# Access Compliance Report

## Public Rights-of-Way

### (Curb Ramps)

Intersection ID: 48459	Main Street: TARPWAY_RD	Cross Street: QUINN_DR	Location: NE
ADA ID: B11CD0D86676	Ramp Type: PerpDiag	Initial Pass/Fail: Fail	Overall Compliance: No
Codes/Mitigation Info/Possible Solution		Field Measurements/Component Compliance	
Severity Score: 33.75

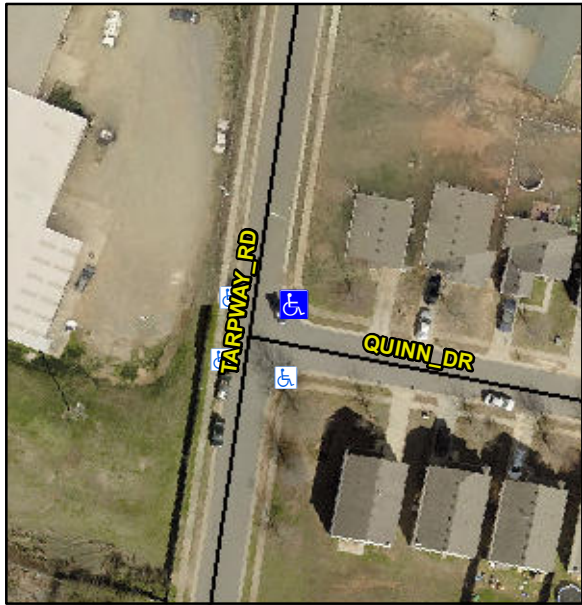
Not Found, R304.5.1, R304.2.2

Compliance	Description	Data	Compliance	Description	Data
N/A	Ramp Length (in)	46.0	No	Ramp Slope (%)	14.6
No	Ramp Width (in)	43.5	Yes	Ramp XSlope (%)	0.0
N/A	Flare Type LT	N/A	N/A	Flare Type RT	N/A
N/A	Flare Slope LT (%)	N/A	N/A	Flare Slope RT (%)	N/A
N/A	Flare Traversable LT?	N/A	N/A	Flare Traversable RT?	N/A
N/A	Landing Length (in)	N/A	N/A	DWS Provided?	N/A
N/A	Landing Width (in)	N/A	N/A	DWS Contrast?	N/A
N/A	Landing Slope (%)	N/A	N/A	DWS Length (in)	N/A
N/A	Landing X Slope (%)	N/A	N/A	DWS Full Width?	N/A
N/A	Landing Curb? (Y/N)	N/A	N/A	DWS Offset (in)	N/A
N/A	Shared Landing?	N/A			
N/A	Gutter Ponding?	N/A	N/A	Gutter Slope (%)	N/A
N/A	Gutter Lip Ht (in)	N/A	N/A	Gutter X Slope (%)	N/A
N/A	Painted X Walk1?	No	N/A	Painted X Walk2?	No
	X Walk 1 Direction	To NW		X Walk 2 Direction	To SW
N/A	X Walk 1 Width (in)	N/A	N/A	X Walk 2 Width (in)	N/A
	X Walk 1 Slope (%)	2.0		X Walk 2 Slope (%)	1.9
	X Walk 1 X Slope (%)	1.8		X Walk 2 X Slope (%)	3.5

Remove & Replace Curb Ramp With Two New Directional Ramps or Equivalent.
